# ADA Curb Ramp New Construction Inspection Form (Perpendicular)

Nw 291 st

23885.56

Nw fair st

## PERPENDICULAR RAMP (PR)

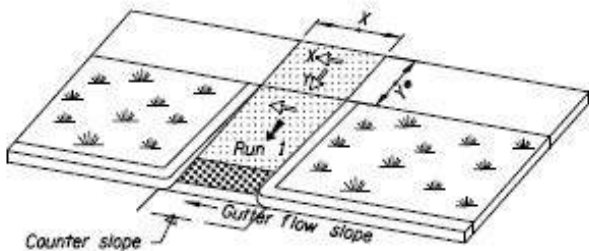
Turn space less than 4 clear width IITD not full width rr1 icrr
